**To:** Eoanna Goodwin - Project Manager, RPD Capital and Planning Division

**From:** John Romaidis - Disability Access Coordinator, RPD Capital & Planning Division

**Subject:** Embarcadero Plaza - Accessibility Assessment

Figure 3. NW Walk

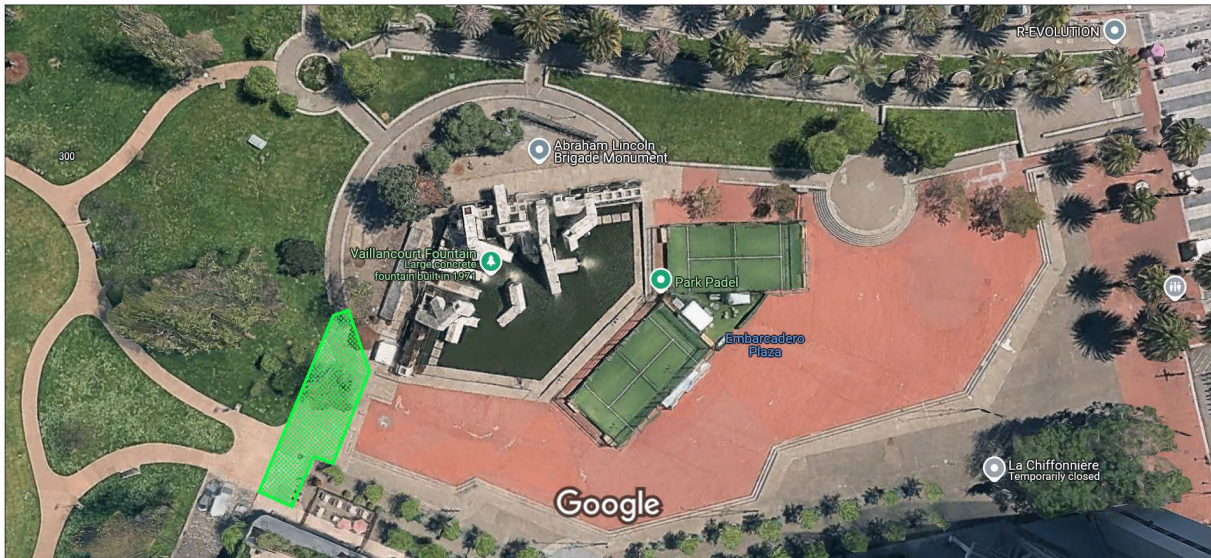
The NW walk is a primary access route connecting Clay Street and Sue Bierman Park to the plaza. This area is in severe disrepair. Significant concrete upheaval has resulted in extreme cross slope conditions and vertical level changes, creating major accessibility barriers.

Repair concrete walkways to correct excessive cross slopes and vertical displacements. Provide compliant transitions throughout.

Figure 5. SW Walk

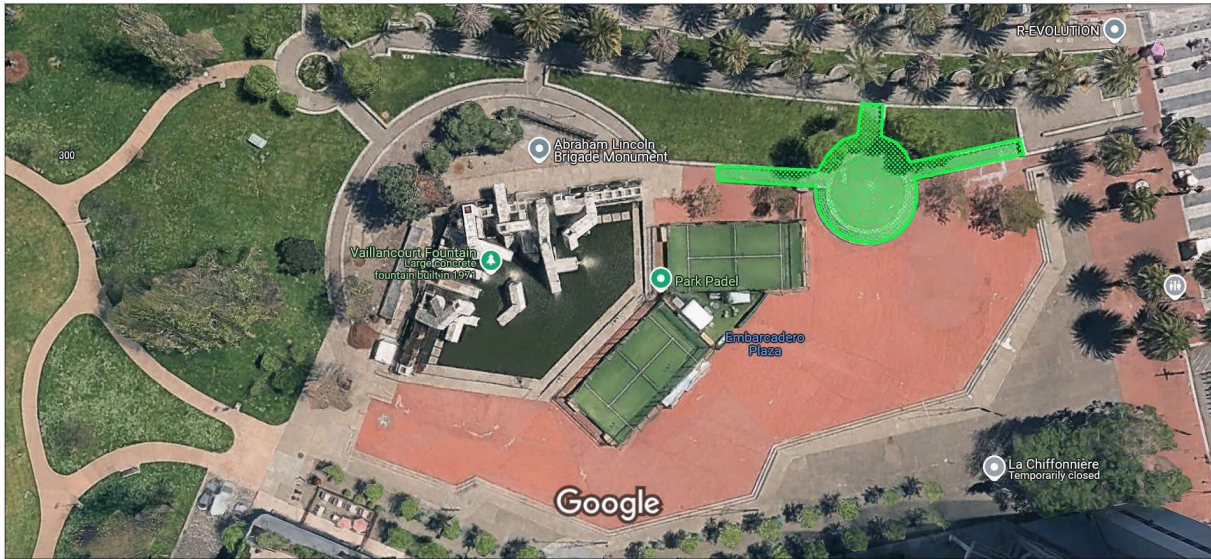
The SW walk consists of two sloped paths that descend from a semi-circular stair and raised platform area overlooking the plaza. Portions of the walk exhibit running slopes exceeding the 5% maximum (up to 6%). No cross-slope issues were noted. At the north end of the stairway, an electrical cabinet or device encroaches into the required 48-inch stair landing depth

Repair walkway segments with excessive running slope. Relocate the electrical equipment or reposition the handrail to maintain the required landing depth.

Figure 6. Sloped Walks

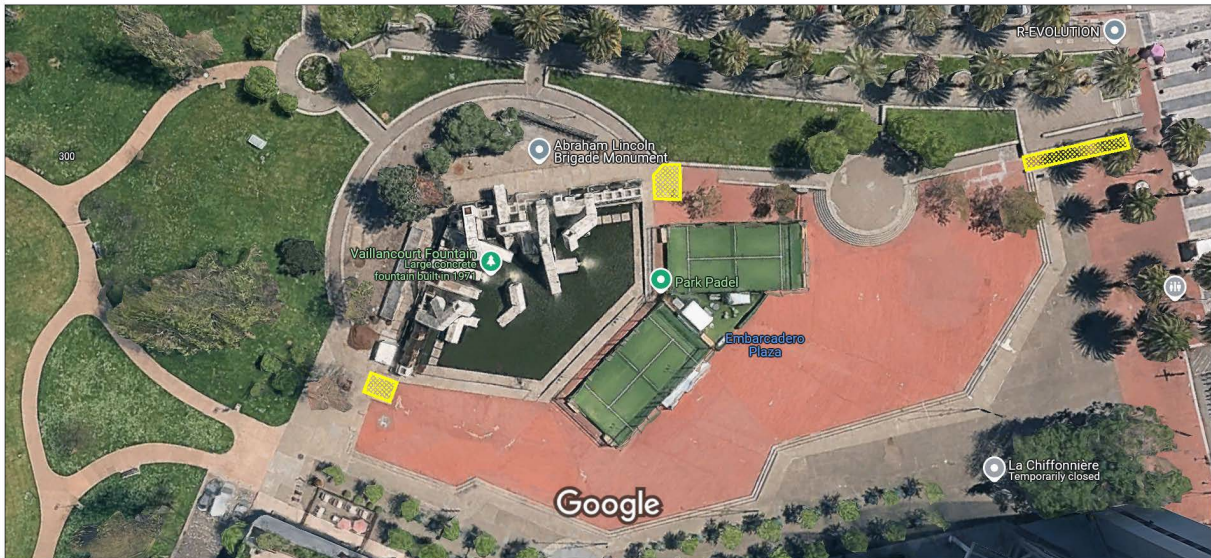
- The north sloped walk is in poor condition, with significant cross slope issues and deteriorated surface conditions.
- The east sloped walk has a running slope measured at 9.9%, which exceeds the maximum allowable 5%.
- The south sloped walk, which connects from Market Street, was observed to be compliant in both slope and surface condition.

Repair sloped walk entries as necessary to correct excessive cross-slopes and running slopes.

Figure 7. Plaza

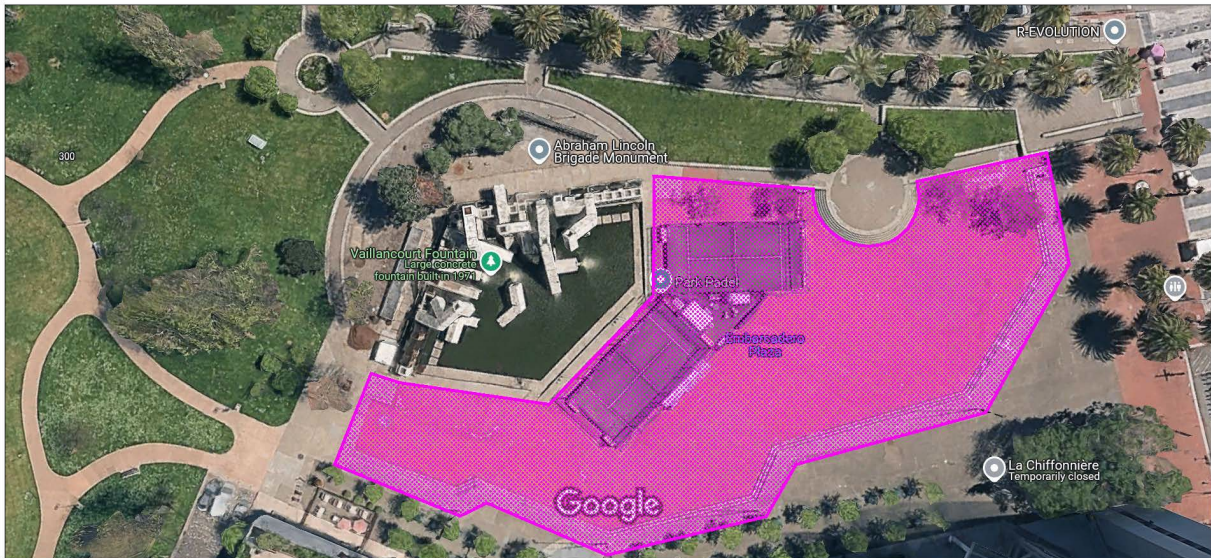
The brick plaza is accessed via three primary sloped entries, as well as a continuous set of steps along the south and west edges. Overall, the plaza gently slopes downward toward the Vaillancourt Fountain. While much of the area appears relatively flat, approximately half of the surface exhibits accessibility issues due to localized non-compliant cross-slopes and irregularities caused by brick displacement and settlement.

- Cross slopes ranging from 2.9% to 10%, primarily concentrated on the western portion of the plaza.
- Cross slope issues at fountain border
- Surface undulation and unevenness at the top and bottom approaches to the steps.
- Missing handrails at the stairways.
- Lack of visual contrast (striping) at stair treads

Repair brick plaza surfaces as needed to correct excessive cross slopes. Repair approach areas at stairways. Install compliant handrails and provide visual contrast (e.g., contrasting stripes) on stair treads.
